Reserved Matters Application AL/27/26/RES
Land West of Lidsey Road (A29), Lidsey

I write further to the submission of the above application and following review of consultation responses to submit amendments to the scheme to positively address the feedback received, on behalf of my client BDW Trading Limited (care of Barratt David Wilson Homes Southampton Division).

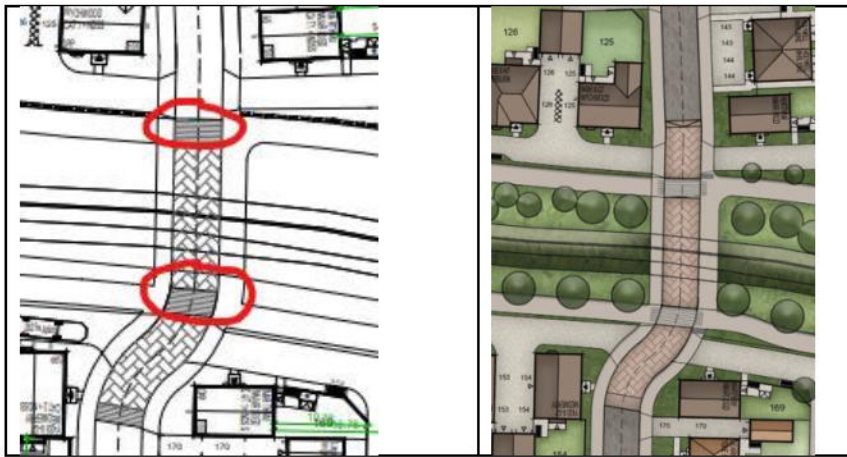
- Tactile paving isn't shown at junctions and adjacent to crossings. This will need to be picked-up at detailed design and/or S38 stage

Response: Notwithstanding that this detail can be addressed at detailed design/S38 stage, the site layout plan has been updated to show tactile paving at all junction locations

Original Submission:	Amended Submission:
-----------------------------	----------------------------

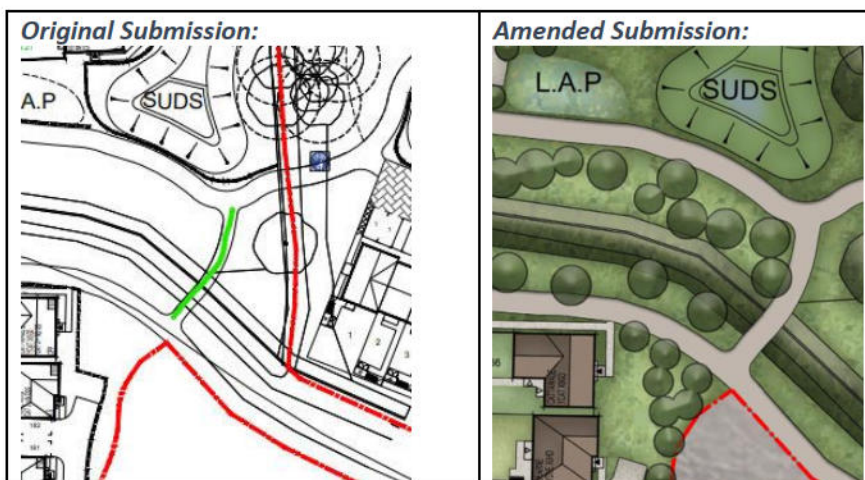
- Is pedestrian and cycle prioritisation proposed here across the carriageway?

Response: The raised table has been extended between plots 125 & 145, to reinforce pedestrian/cycle priority of the central crossing, as follows:

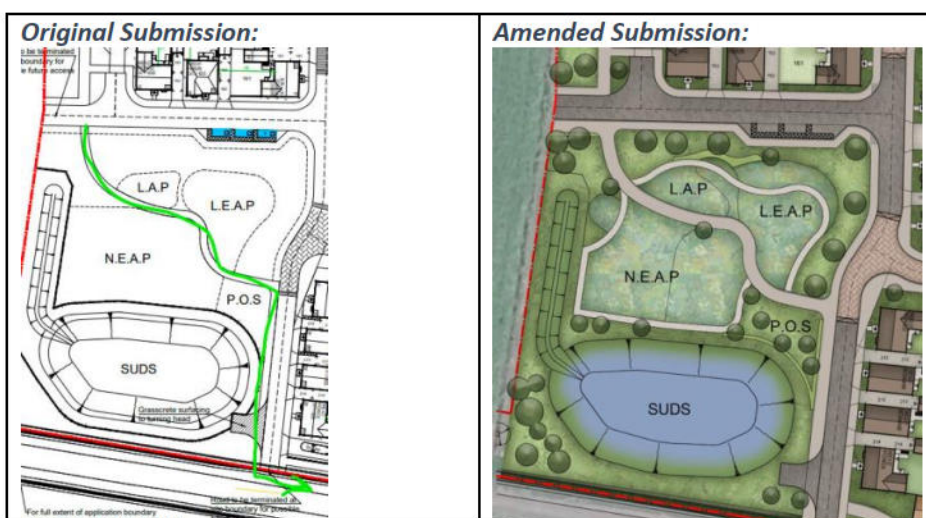
- Recommend that this path be widened to provide shared foot and cycle use
[Response:](#) The path north-east of Plot 166 has been revised to 3m, as follows:

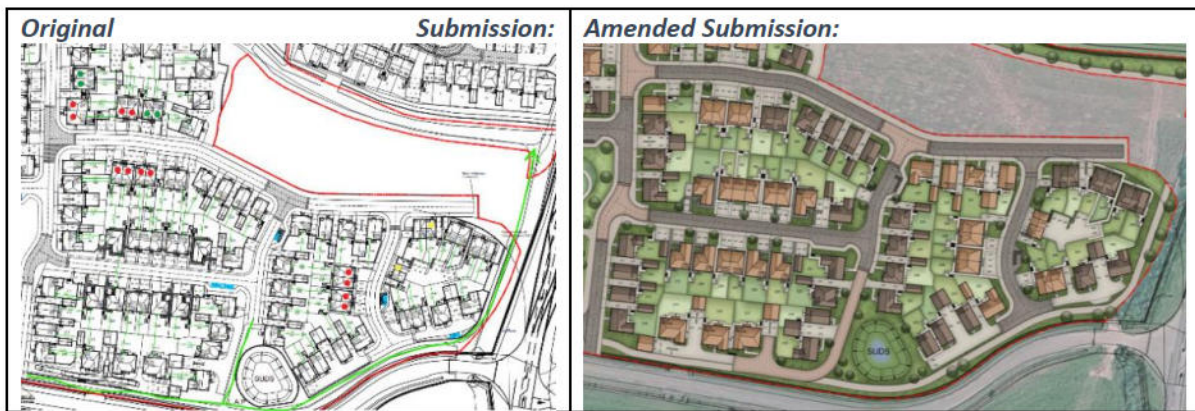
- The following should also be considered for shared foot and cycle use
[Response:](#) The central path through the open space in the south-west of the site has been revised to 3m, as follows:

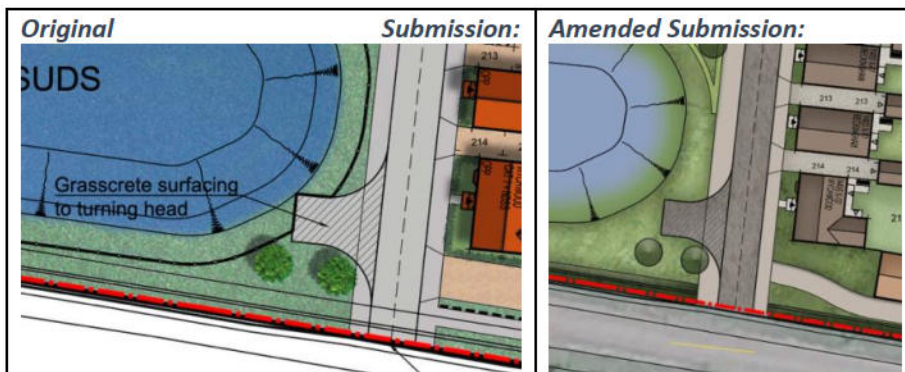
- Turning for occupiers of plot's 166 and 167 looks to be restricted. Swept path analysis required
[Response:](#) The turning for private cars for these plots is shown on submitted tracking drawing DS_0707_15/INF/284 Rev. D
- The 'Grasscrete' turning head adjacent to the SUDS area in the south-western part of the site would not be suitable for adoption in that form of construction. If the intention is to adopt it and the adjoining road it is shown connecting to, it would need to be traditional asphalt construction.
[Response:](#) The specified turning head has been amended to asphalt, as follows:

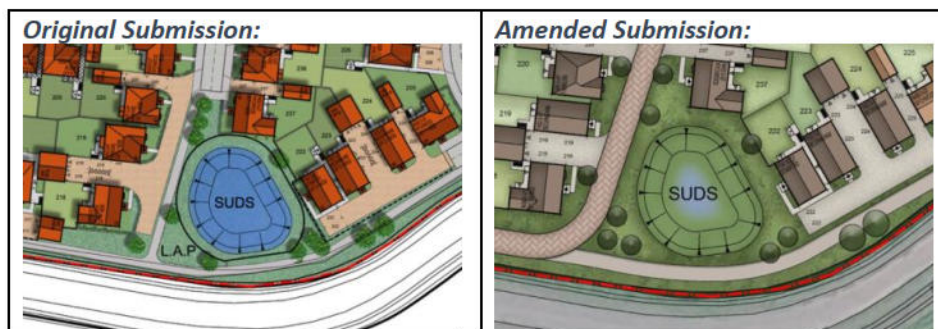
- External visitor cycle parking spaces should be provided adjacent to play areas
[Response:](#) Cycle parking has been included on the revised landscaping plans for the play areas, as requested.
